**PLANNED UNIT DEVELOPMENT
& SUBDIVISION STAFF REPORT****Date: December 20, 2007****DEVELOPMENT NAME**

Perch Creek Preserve

CONTEMPLATED USE

Planned Unit Development Approval to allow a gated, 18'-wide, aggregate- surfaced private street single-family residential subdivision with reduced lot widths and sizes, reduced front and side setbacks, and increased site coverage of 50%.

SITE PLAN

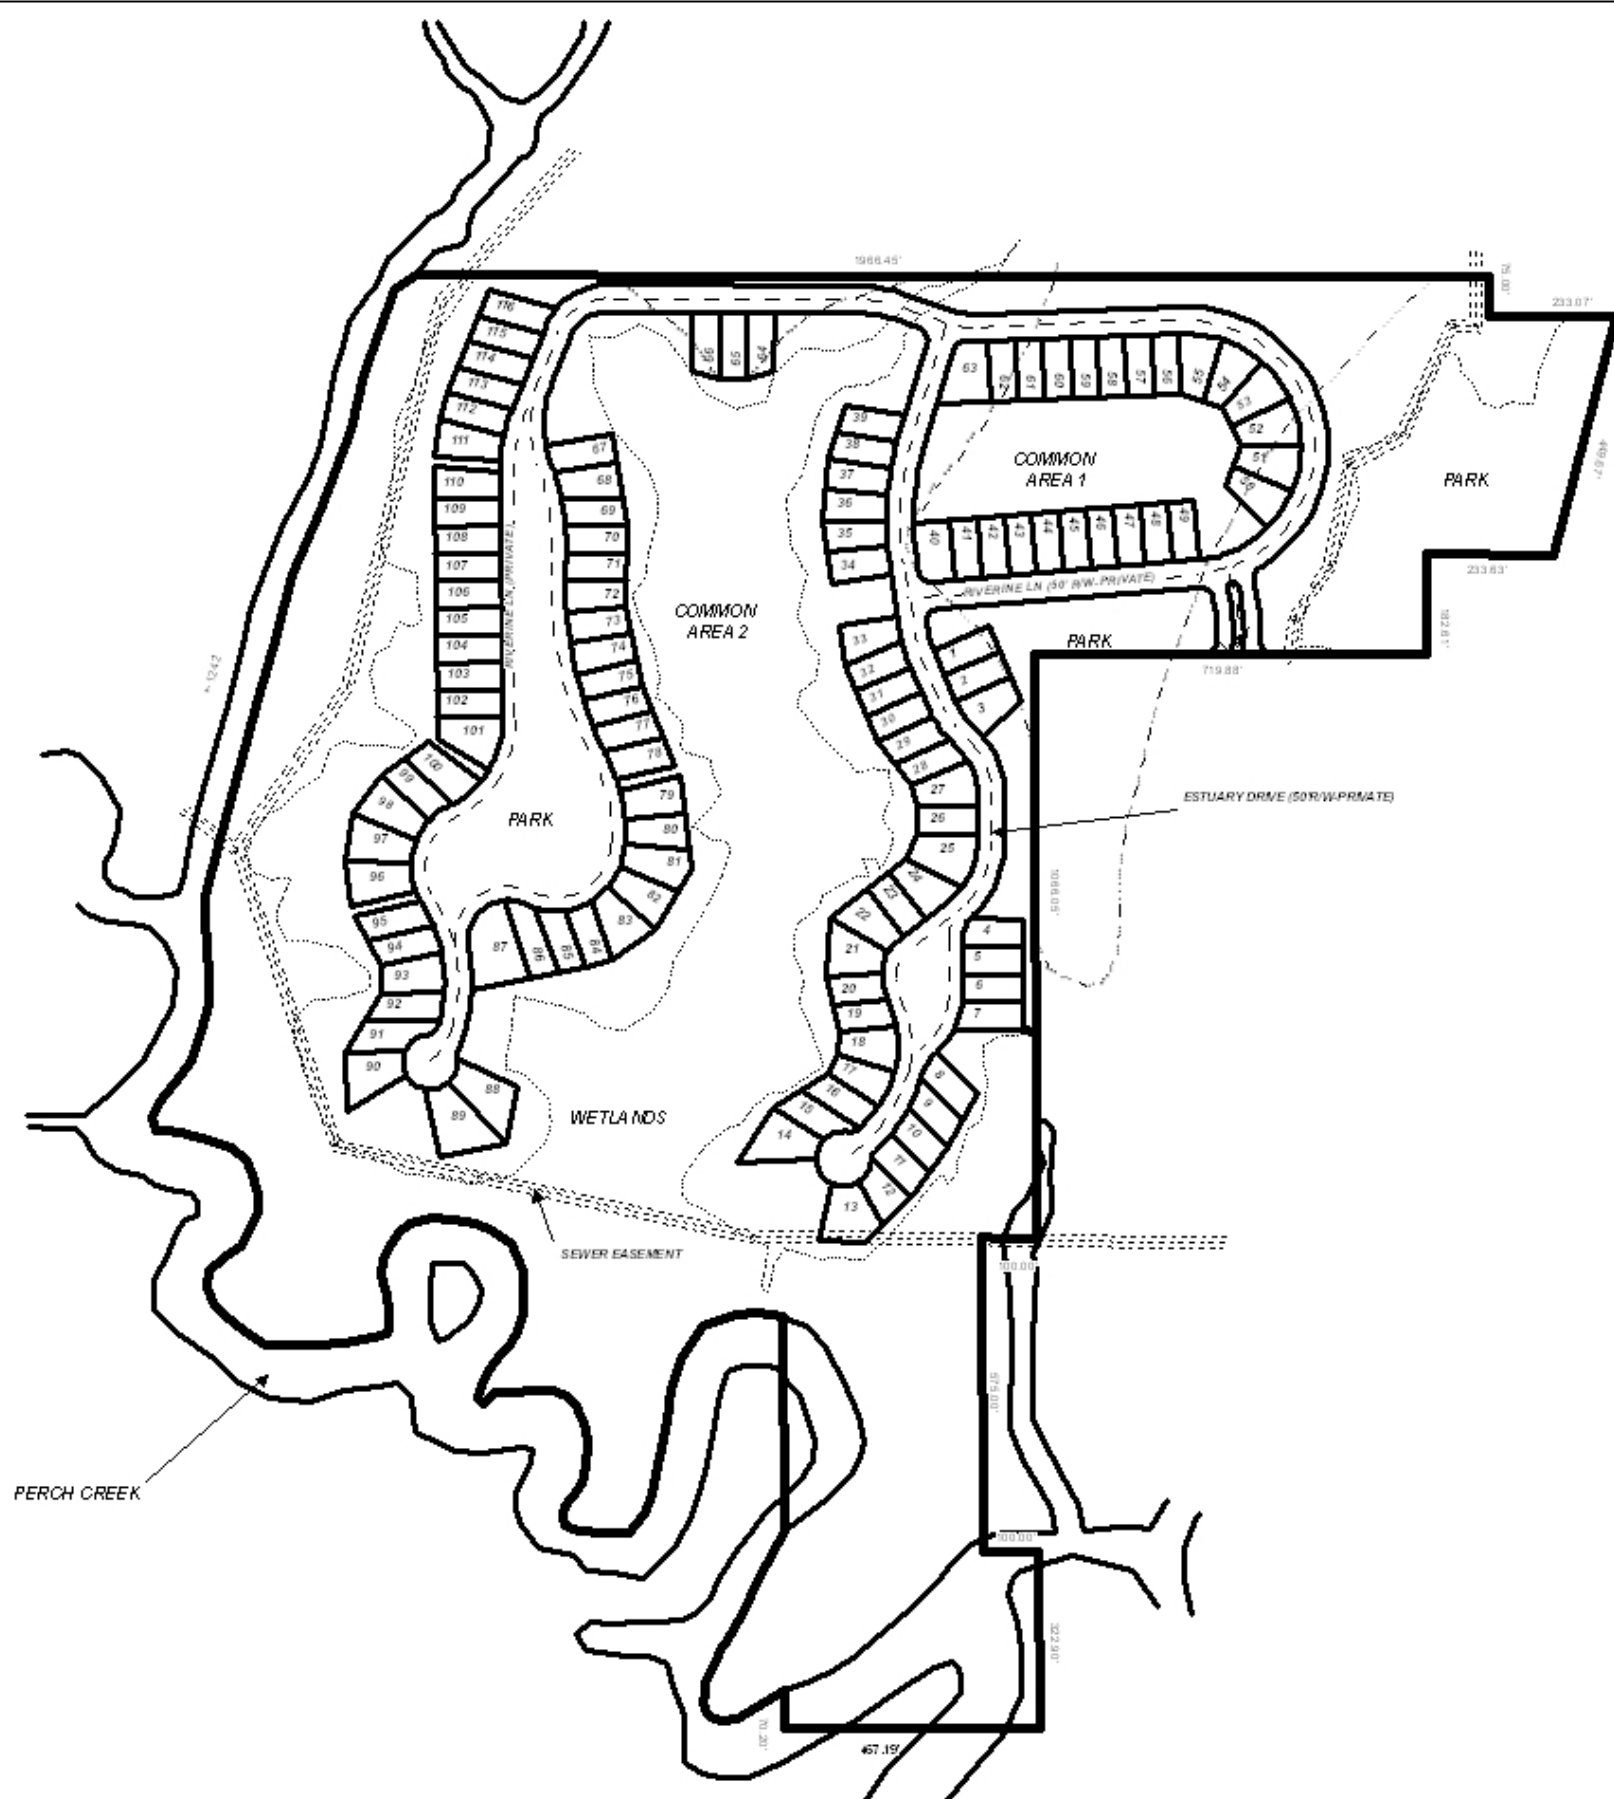
Another issue is that the development proposes a 50' private street right-of-way, as required by the Subdivision Regulations. However, the streets are proposed to be 18' streets with a ribbon curb (the regulations require two 2' asphalt wings), and 14' one way lanes. The surfacing is proposed to be aggregate, instead of the minimum standard asphalt paving required in the Subdivision Regulations. The issues here relate to MFD requirements, based upon the 2003 International Fire Code (Section 503 which states that the minimum width of an apparatus access street is to be 20', and where adjacent to a hydrant the minimum width is to be 26'), and appendices C & D.

The proposed private streets exceed the maximum length for a cul de sac or closed end street as stated in the Subdivision Regulations, the park areas indicated in the middle of the private street rights-of-ways may be sufficient to allow for a longer cul de sac and allow a fire truck to turn around. However, no information is provided as to the level of clearing and/or improvements there may be in these areas that would address these concerns.

Another issue is that the locations of the one-way and two-way surfaces are not shown on the plan, nor are the areas intended for asphalt or pavers. PUD Approval is site plan specific, therefore the plan should reflect the locations of the one-way and two-way surfaces, and the paving sections.

The plan denotes several areas as "PARK" and others as common area. Neither the narrative nor the plan reference the difference between the two, nor whether the "parks" are to be private or dedicated parks.

- 1) submit a Flood Study;
- 2) submit a Traffic Impact Study;
- 3) Revise the plan to comply with the International Fire Code (specifically, but not limited to, Section 503);

- 4) Revise the plat to illustrate locations of one-way and two-way surfacing, and areas of asphalt paving or pavers;
- 5) submit justification for aggregate surfacing in lieu of paved surfacing as required by the Subdivision Regulations;

- 6) Revise the plan to illustrate areas of clearing and/or improvements within the park areas illustrated in the private street rights-of-ways;
- 7) provide information regarding the areas denoted as "Park", explaining the difference between "Park" and "Common Area", and if the "parks" are to be private or dedicated parks;

- 8) provide verification of the adequacy of the culvert/structure on Winston Road to accommodate fire apparatus and the increased traffic generated by the development;

- 9) placement of a note on the plat stating that the approval of all applicable federal, state and local agencies shall be provided prior to the issuance of any permits or land disturbance activities;

- 10) Placement of a note on the plat / site plan stating that approval of all applicable Federal, state and local agencies is required for endangered, threatened or otherwise protected species, if any, prior to the issuance of any permits or land disturbance activities; and

- 11) revision of the plat to reflect minimum finished floor elevation and square footage for each lot.
